# INITIAL FIRE SAFETY INSPECTION REPORT

**Talisman Ltd. (New Unit)**

**RSC ID: 25742**

**Date: 06-May-2024**

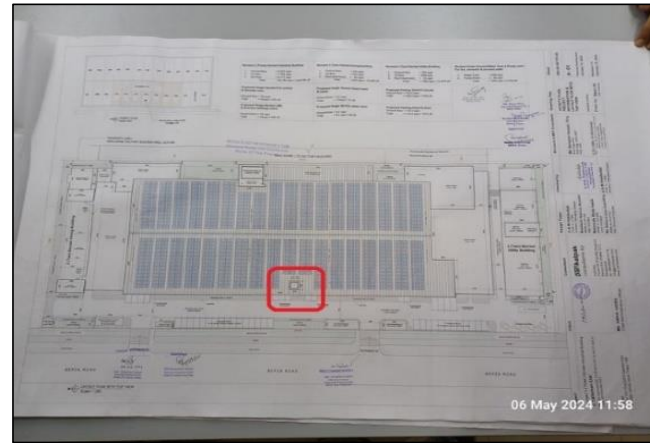
F-2	Fire Rated Construction	Storage room discharges directly into exit stair enclosure on 1st floor and ground floor . Location: Building-1	Openings from exit enclosure to storage room spaces shall be provided with a vestibule with fire rated construction and openings. Provide a 1 hr. fire rated door on the exit stair side and a 1- hr. fire rated door on the storage side. Ensure that the fire rating of the vestibule construction matches that of the exit stair enclosure.	Within 3 months
-----	-------------------------	--	--	-----------------

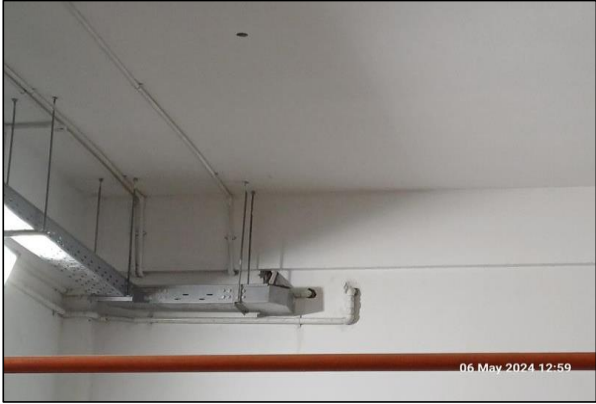
F-4	Fire-Rated Construction	Elevator shafts are directly open into production floor without proper fire separation.  Location: Building-1	Ensure a minimum 1.5-hr fire rating for the doors of elevator shafts otherwise close the shafts area with a 2-hr fire-rated construction barrier and 1.5-hr fire-rated doors.	Within 3 months
-----	-------------------------	---	---	-----------------

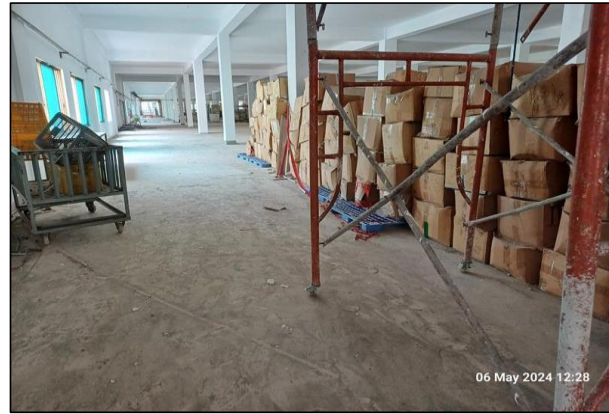
F-10	Means of Egress	Building did not have stair designation signs, occupant load signs and evacuation maps at required locations on all floors. <b>Location:</b> Typical for all structure.	Provide stair designation signs, occupant load signs and evacuation maps at required locations.	Within 1 months
F-11	Means of Egress	Handrails are not provided on both sides of the north-east and south-east exit stair on all floors. Location: Building-1	Provide handrails on both sides of the exit stair. Intermediate handrails shall be provided when the stair width exceeds 2.2 m (87 in. New handrails shall have a minimum height of 865 mm (34 in.) and a maximum height of 965 mm (38 in.) as measured from the leading edge of the tread.	Within 1 month
